**SUBJECT: Police Headquarters WJE Clarification Letter – Phase 2 Peer Review Report – Life Safety Category**

**SUBJECT: New Police Headquarters — Phase 2 Peer Review**

Figure 41. Conceptual rectification of sliding deficiency of mat footing CF-1. The mat footing is attached to nearby isolated footings (J3, K3, and K4) with new reinforced concrete (shown in blue font)

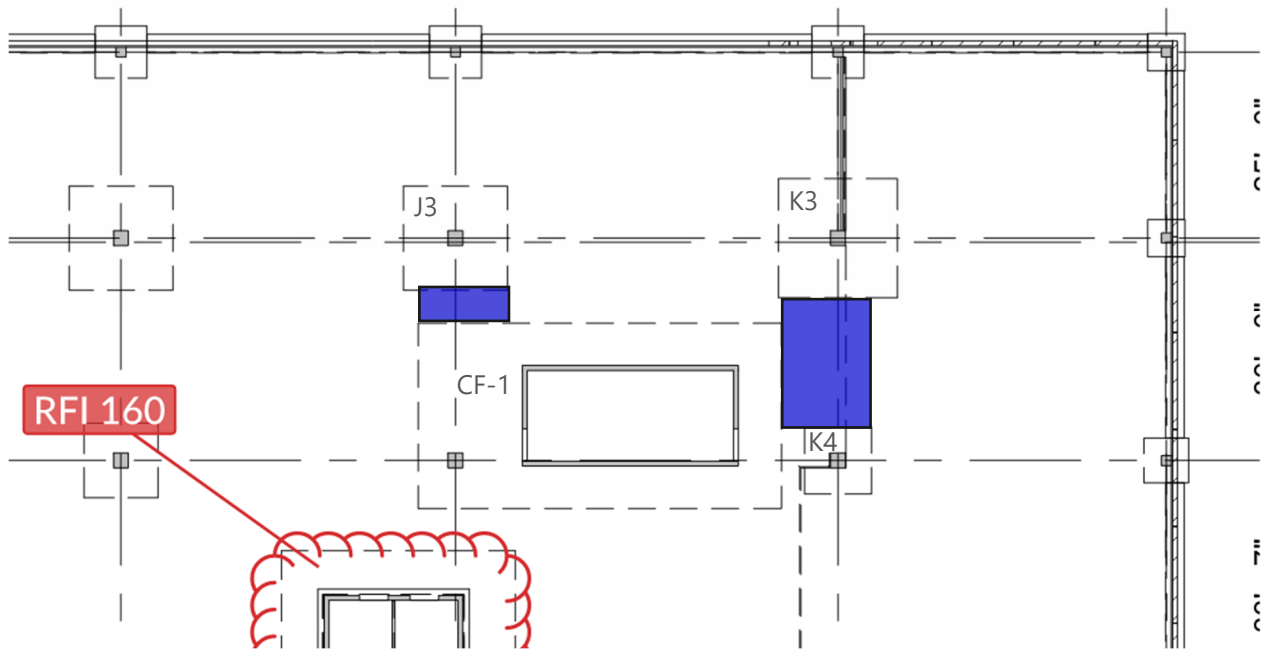
The addition of a shear wall at the location recommended in Figure 40 will not fully rectify the sliding deficiency of mat footing CF-1 (under the north stair shaft). One way of enhancing the sliding resistance of this footing is to connect or tie it to adjacent column spread footings, as illustrated in Figure 41. If CF-1 is connected to the column spread footings at Grid Points J/3, K/3, and K/4, the additional gravity load on these columns will provide additional frictional resistance against sliding resistance for the combined foundations. To connect the footings, new segments of reinforced concrete foundations can be cast. These new tie footing sections should have sufficient strength to transfer the lateral sliding loads from the mat footing and column spread footings. The new tie footings would also need to be reinforced to preclude other limit states such as (e.g.,) one-way shear.
